Title: **STAGE 2 ROAD SAFETY AUDIT**  
**For;**  
**Main Street Ardee**

Client: **Louth County Council**

Report reference: **2067R02 Rev 2**

VERSION: **March 2025 Addendum.**

Drawing HDC1256 107 Rev 07, South of Dee River bridge.

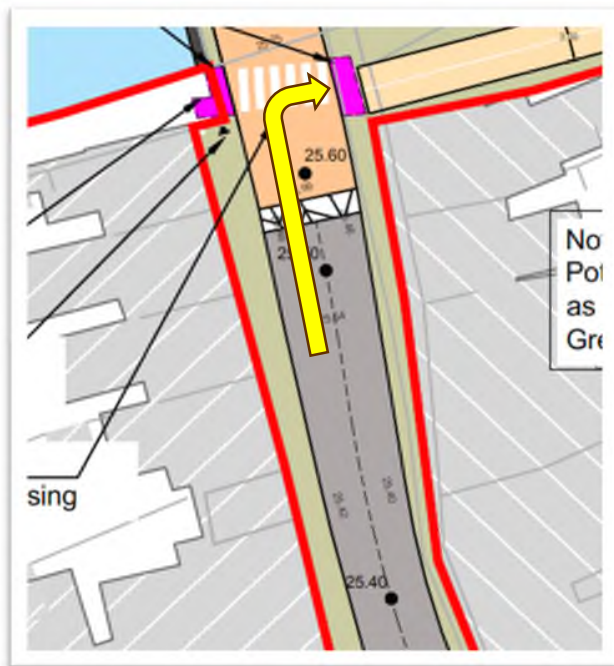
There is no provision for northbound cyclists to exit the N2 and wait to cross the signalised crossing. Cyclists will therefore continue travelling northbound on the Main Street carriageway thereby increasing the risk of collisions with general traffic. A proposal to direct cyclists via Hale Street was suggested in the Feedback Form of the Stage 1&2 Road Safety Audit. That proposal does not appear to be included in this design update.

It is recommended that a transition from on-road to off-road be provided for cyclists.

3.4	Yes	Yes	N/A	
3.5	Yes	Yes	N/A	
3.6	Yes	No	There is inadequate space available to the south of the bridge to accommodate an on-road to off road transition directly south of the Bridge Street bridge. Additional road signage will be proposed at the junction of the N2 / R170 which will direct cyclists approaching from the south in this direction. Further signage at the junction of the R170 / Hale Street will direct cyclists to turn up Hale Street to join the start	Yes

Drawing HDC1256 107 Rev 07, Pedestrian Crossing at Ardee Castle.

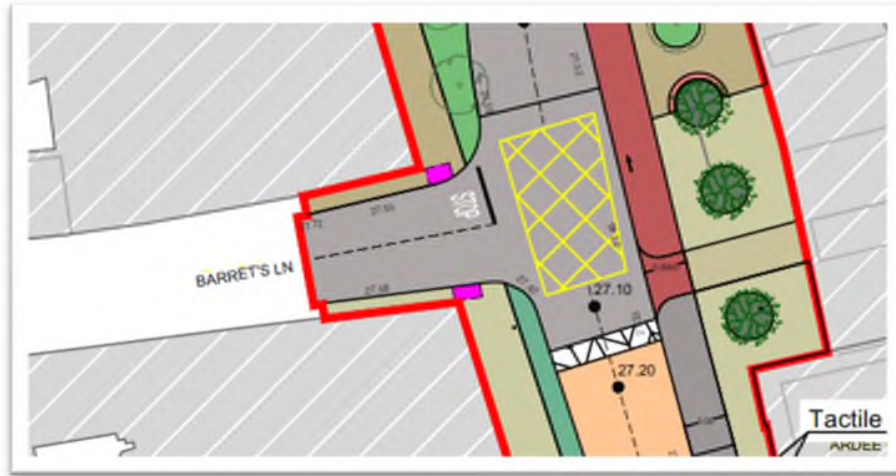
The pedestrian crossing at Ardee castle has a two-way cycle track on the eastern side. A lack of warning could lead to blind or partially sighted pedestrians not realising they are sharing space with cyclists.

It is recommended that a well-defined shared area be provided with suitable ladder and tramline tactile paving at either side. This applies to other similar crossings throughout the scheme.

3.14	Yes	Yes	N/A	
3.15	Yes	Yes	Swept path analysis has been undertaken and no issues identified.	
3.16	Yes	Yes	N/A	
3.17	Yes	Yes	N/A	
3.18	Yes	Yes	The shared surface will be designed to decrease vehicle speed without the requirement for a physical speed control restraint.

Drawing HDC1256 107 Rev 07, N52 Barret's Lane.

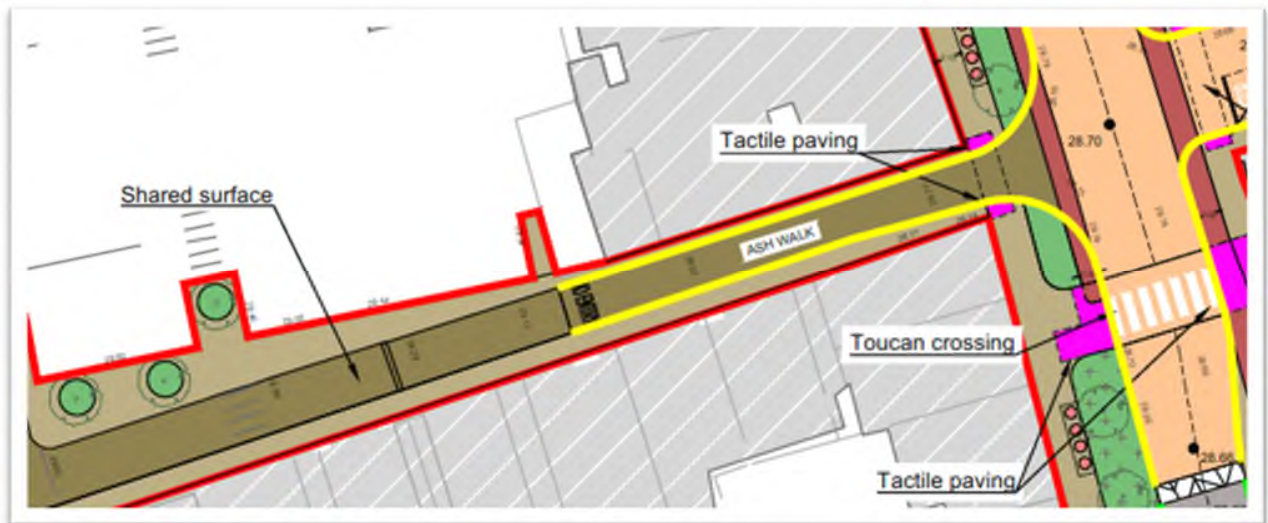
The N52 is a national secondary road which is proposed to bypass Ardee in the future as part of a separate scheme. There is however no guarantee that this scheme will progress and a high volume of HGVs will continue to use the N52 if this scheme progresses. Although the N52 junction is being built out from its current layout it is unclear if HGVs will be able undertake the turning manoeuvres from and to the N2 in both directions. A lack of space would lead to overrunning of the footpaths, cycle track or side swipe/head-on collisions with other vehicles.

It is recommended that a swept path analysis be carried out for HGVs to ensure that turning manoeuvres can be undertaken. If this cannot be achieved a signalised junction may be required.

Drawing HDC1256 106 Rev 06, Ash Walk, Shared Street.

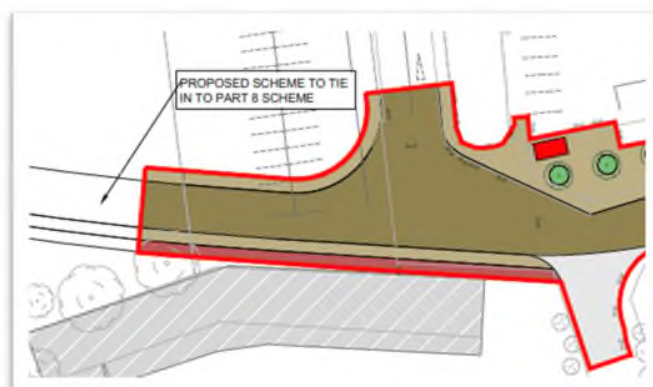
Ash Walk is shown to be a 'Shared Street' It is unclear what distinguishing features or what signage will be provided to indicate this to users, especially drivers, as they enter this area. It appears that the footpaths are to be retained beyond the initial section from the N2 which does not signify a shared street but segregated facilities for pedestrians. A lack of clarity can lead to drivers presuming priority resulting in collisions.

It is recommended suitable details be provided to denote a 'shared street' at its transition from the N2.

Drawing HDC1256 106 Rev 06, Ash Walk.

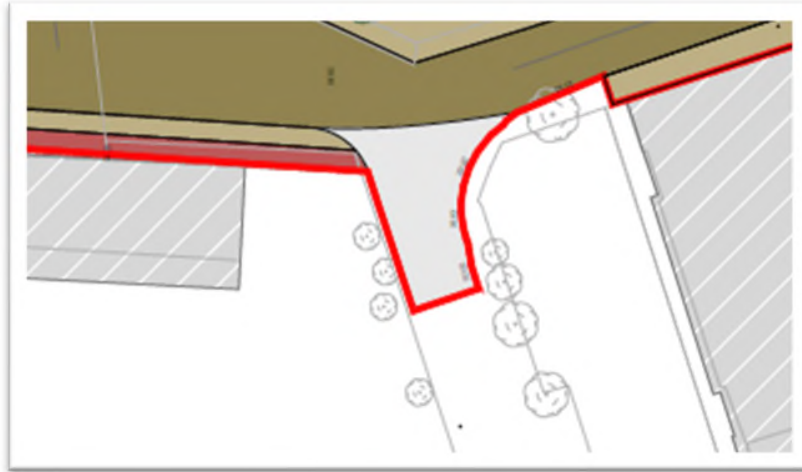
Ash Walk is relatively long and straight and one-way. This could lead to high vehicle speeds. High speeds leads to high injury severity if a vulnerable road users is struck by an errant vehicle.

It is recommended that traffic calming be provided along Ash Walk. (It is unclear if an existing raised table is to be retained)

Drawing HDC1256 106 Rev 06, Ash Walk, tie in with link road to the N52.

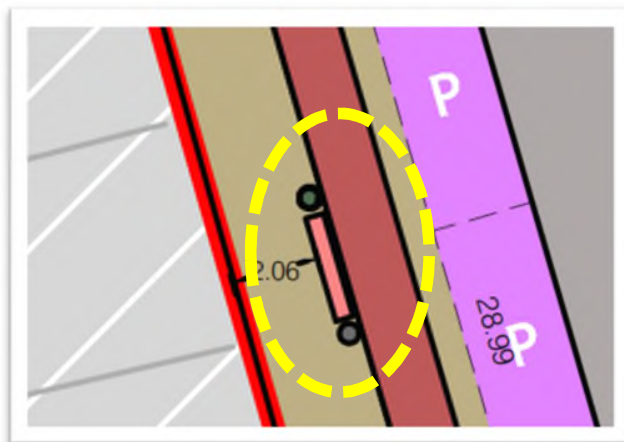
The link road to the N52 from Ash Walk is not shown to be a shared street. A change of street type could increase the risk of collisions with vulnerable road users.

It is recommended that that consistency in street type be provided or that a suitable transition be provided.

Drawing HDC1256 106 Rev 06, benches adjacent to the cycle lane.

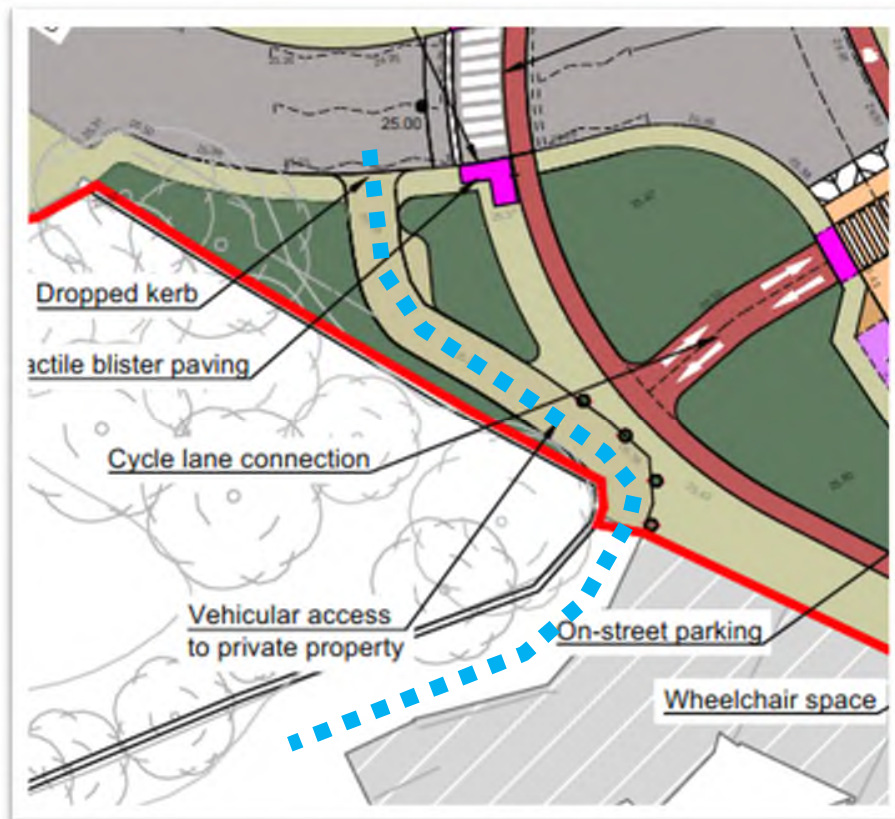
It is proposed to provide benches adjacent to the cycle track. If they are located too close to the cycle track they may be hazards for cyclists who may get their handlebars caught leading to loss of control and falls.

It is recommended adequate offset be provided at the edges of the cycle track without obstacles.

Drawing HDC1256 102 Rev 07, Vehicular Access to Public House.

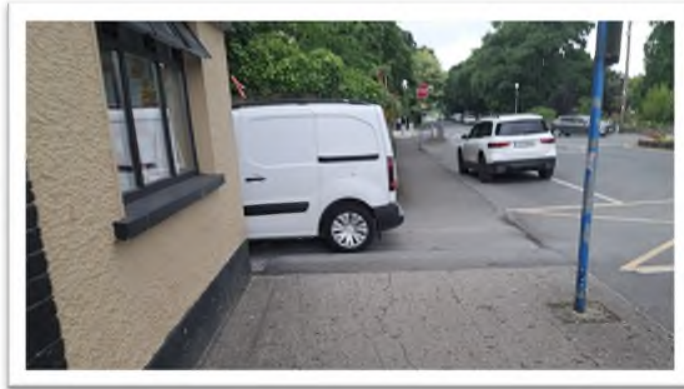
The vehicular access to the car park of the bar at the junction of Golf Links Road is for a single vehicles only. Drivers entering the route will not have inter-visibility to drivers leaving which could lead to reversing onto Golf Links Road resulting in collisions with through traffic or crossing pedestrians.

It is recommended that a passing bay be provided. Depending on the amount of usage this lane may need to be segregated from the pedestrian route.

Drawing HDC1256 102 Rev 07, Golf Links Road Junction.

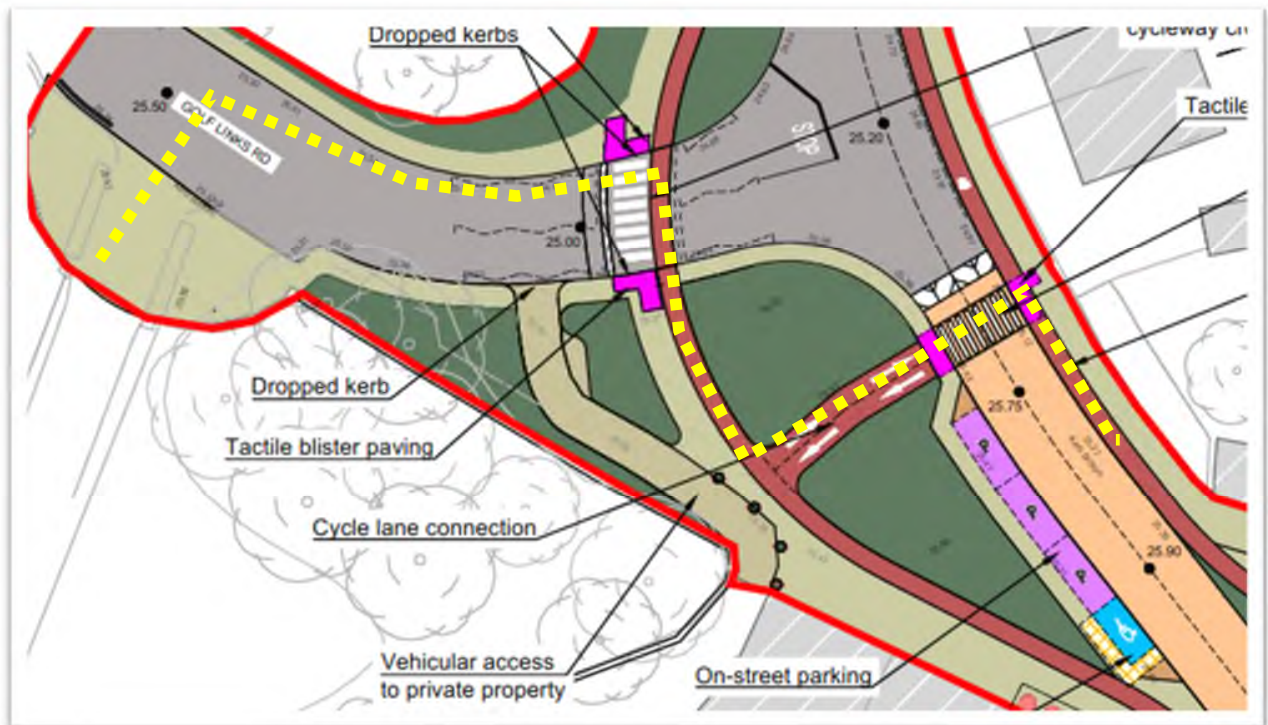
The corner radii at the Golf Links Road junction with the N2 are large. This could lead to high turning speeds and thus higher severity collisions.

It is recommended that the corner radii be reduced

Drawing HDC1256 102 Rev 07, Disabled parking space.

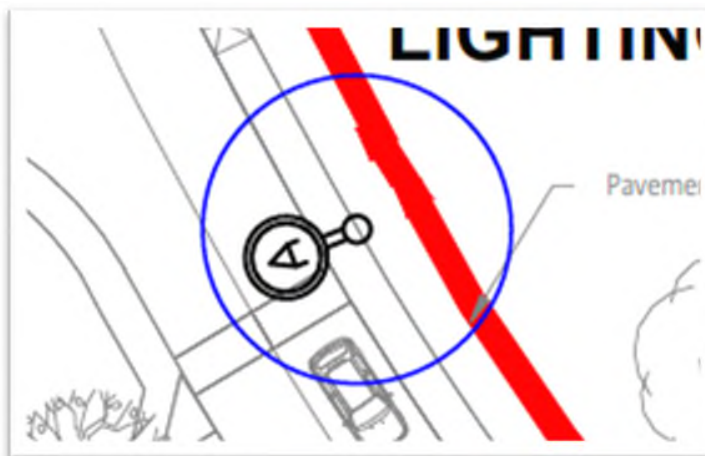
The buffer zone for the disabled parking space to the south of the southbound bus stop coincides with the footpath. It is unclear what the levels will be and if a wheelchair user will be able to use the space freely to access all areas of the car. A lack of space could lead to users entering the carriageway where they would be at greater risk of being struck by a passing vehicle.

It is recommended that the footpath be rerouted to the rear of the buffer zone.

Drawing HDC1256 1002 (K) Rev 03 Kerb Layout, Access to private garage off N2.

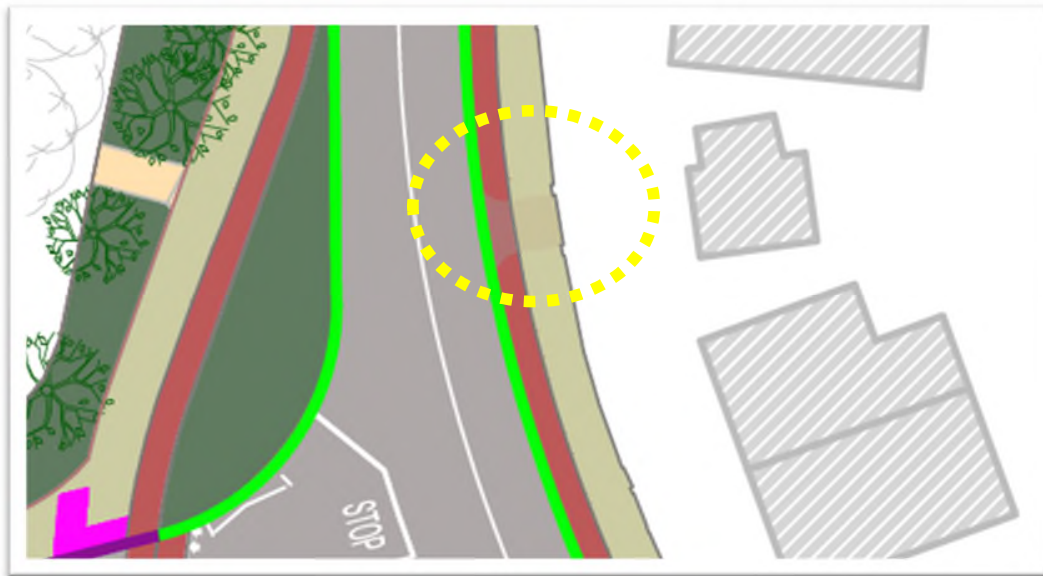
The drawing shows a 125mm high kerb at the proposed vehicular access to the private garage on the eastern side of the N2 just north of the Golf Links Road junction. A high kerb could lead to vehicles 'bouncing back' when trying to access the driveway to the garage resulting in rear-end collisions.

It is recommended that the kerb height be adjusted to facilitate vehicular access.

Drawing HDC1256 1002 (K) Rev 03 Kerb Layout, Relocated Bus stop and bus shelter, south bound.

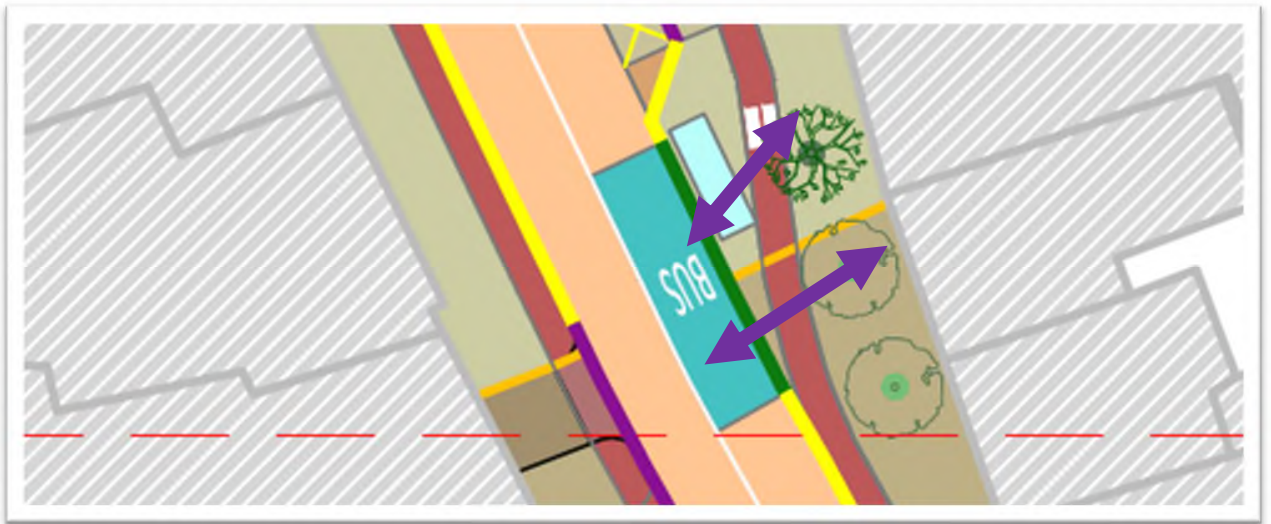
The location of the bus shelter between the bus stop and the pedestrian crossing of the cycle track does not appear to allow enough space for pedestrian movements from the footpath if the shelter will have a back or front panels. This could lead to pedestrians crossing the cycle track away from the highlighted striped areas resulting in a higher likelihood of collision with cyclists who do not expect pedestrians to cross. Also, if passengers alight from the front of the bus there is very little space between where they will step out and the cycle track. This could lead to collisions with passing cyclists.

It is recommended that the layout be changed to provide adequate space for bus users without conflict with cyclists.

Drawing HDC1256 1002 (K) Rev 03 Kerb Layout, Zebra Crossing.

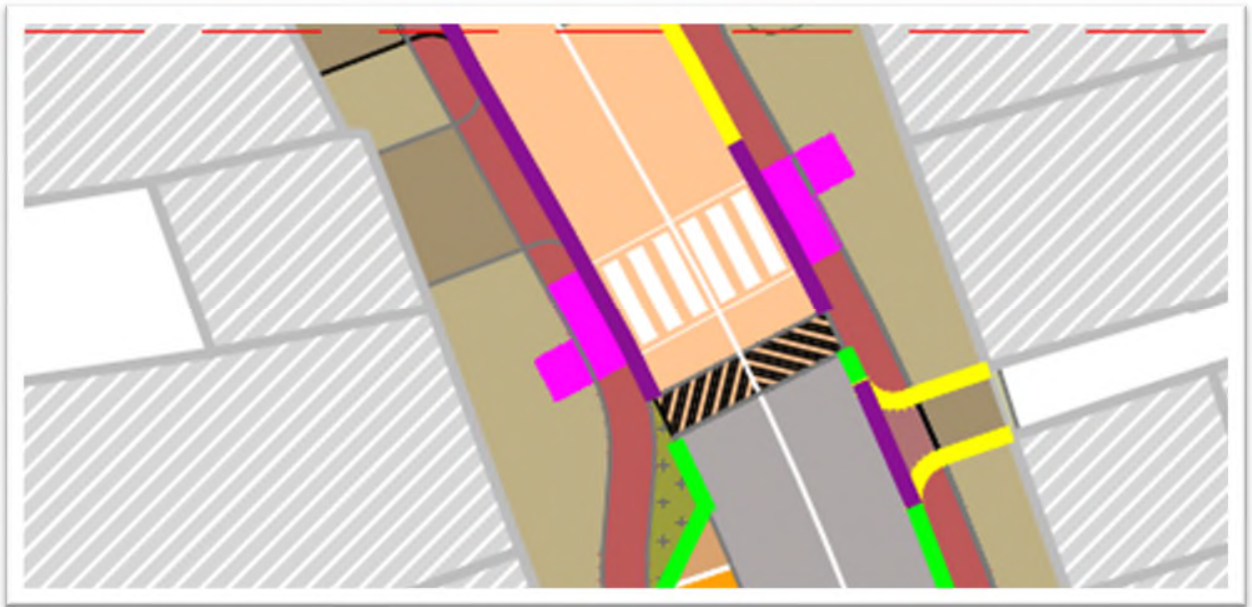
The tactile paving for the zebra crossing is within the cycle lane. It may not be clear to cyclists that pedestrians have priority as they approach the crossing. This could result in collisions between the two user groups.

It is recommended that a shared use area be developed at both sides of this zebra crossing and other similar crossings.

Drawing HDC1256 1002 (K) Rev 03 Kerb Layout, Flush Kerbing.

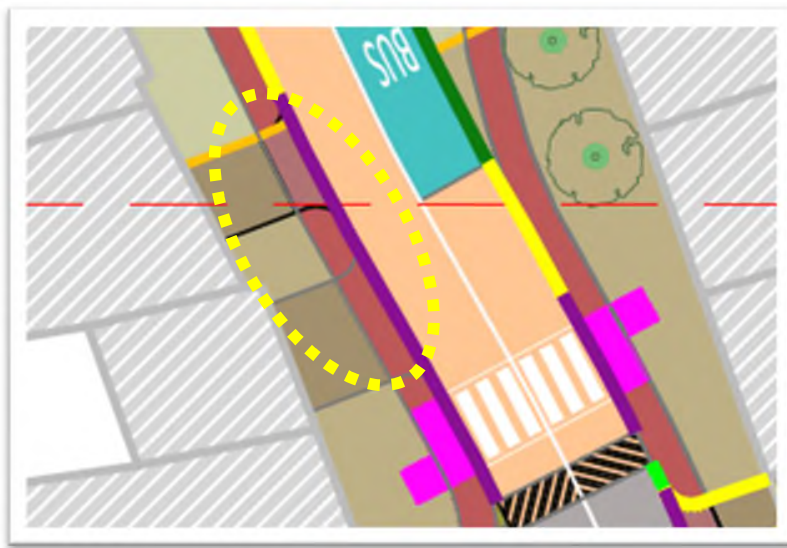
Flush kerbing is provided beyond the extents of the crossing areas at the zebra crossing. A blind or partially sighted pedestrian may inadvertently enter the carriageway if they cannot detect a level difference. This could result in collisions with passing vehicles.

It is recommended that flush kerbs only be provided at crossing points or access areas for pedestrians only.

Drawing HDC1256 1002 (K) Rev 03 Kerb Layout, 50mm high kerbing at accesses.

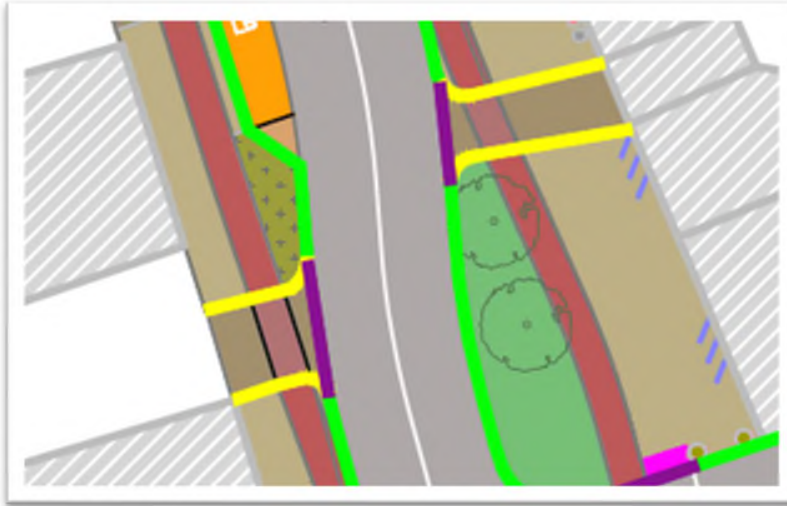
It is proposed to provide 50mm high kerbing at some accesses across the footpath. This would be a trip hazard and would lead to inaccessibility for mobility impaired pedestrians.

It is recommended that flush kerbs be used or no kerbs and that continuous footpath and cycle track facilities be used.

Drawing HDC1256 1004 (K) Rev 03 Kerb Layout, Tactile Paving.

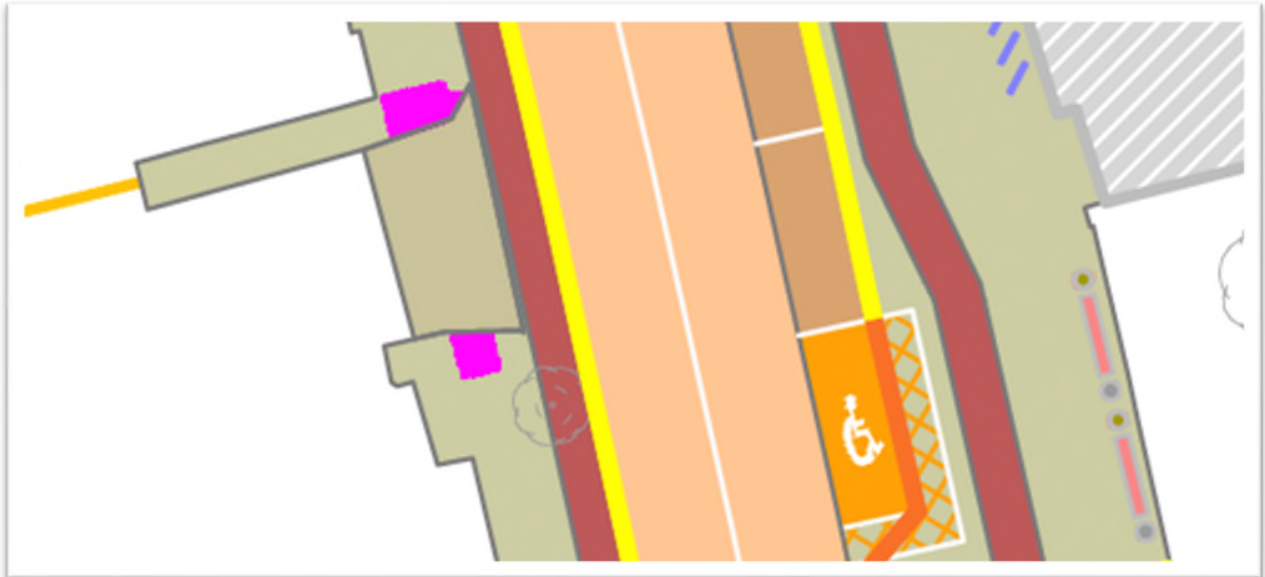
The tactile paving shown at the western side crossing does not match in extent on both sides. There is a risk that blind or partially sighted pedestrians may use the tactile paving as a guide to have completed the crossing however may not detect it is not provided directly across from the start. In addition, the shading for the uncontrolled tactile paving is shown the same as controlled tactile paving. It is assumed that this is just a draughting issue and that buff coloured tactile paving will be used at uncontrolled crossings.

It is recommended that the extent of the tactile paving be matched on both sides.

Drawing HDC1256 1007 (VT) Rev 05, At zebra crossing.

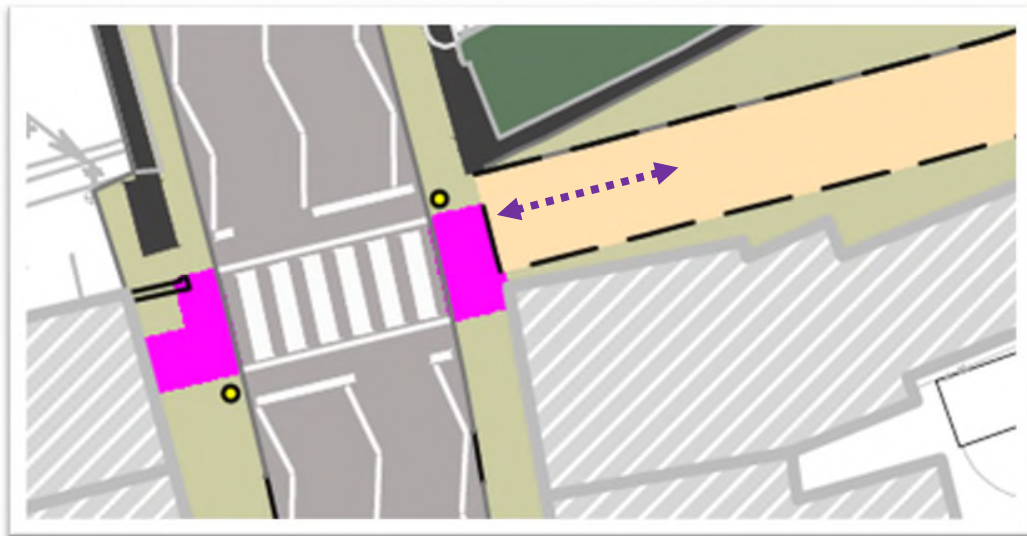
There is a slight misalignment of the extent of the tactile paving associated with the zebra crossing and the shared use path on the eastern side. However this may be required to ensure there is enough room for mobility impaired users to get around the belisha beacon pole. The shape of the tactile paving may be confusing and not help guide a blind or partially sighted pedestrian to the crossing.

It is recommended that a stem be provided on the tactile paving so that such vulnerable road users will know that it is a crossing where they have priority and the stem may be detected by those travelling on the shared use path.
